SAFETY EVALUATION REPORT
Docket No. 71-3043
Model No. MFC-1
Japanese Package Design Certificate No. J/105/AF-96
Revision 2

SUMMARY

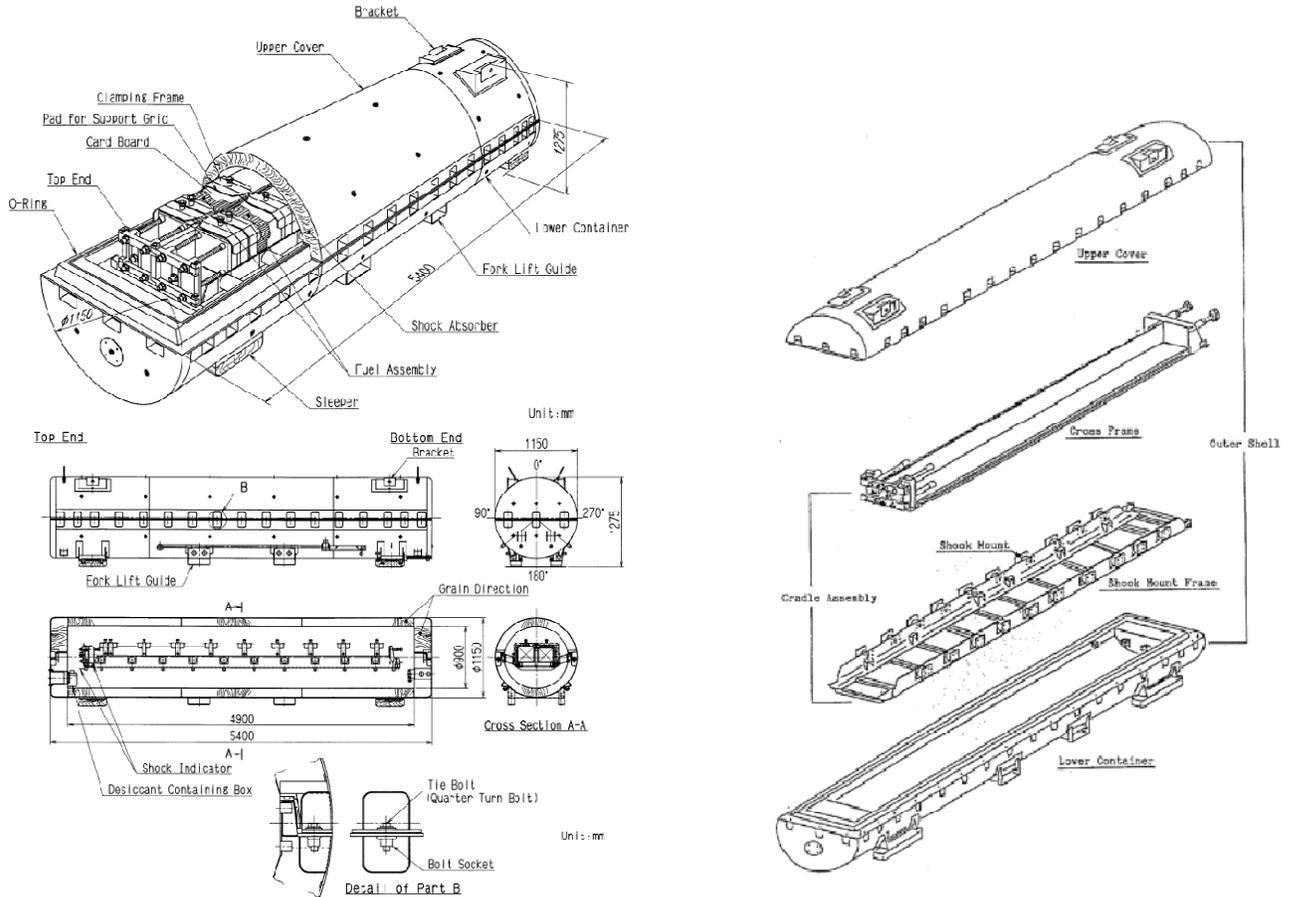
The MFC-1 has the following nominal outside dimensions: an overall length of 5400 mm, an outside diameter of 1150 mm and a height of 1275 mm. The total mass of the package is 4320 kg (2804 kg packaging plus 2 fuel assemblies).

The MFC-1 package consists of an outer shell (comprised of an upper cover and a lower container) and a cradle assembly (comprised of a shock mount frame, mounts, and auxiliary devices). A maximum of two fuel assemblies will be contained and transported in a horizontal position.
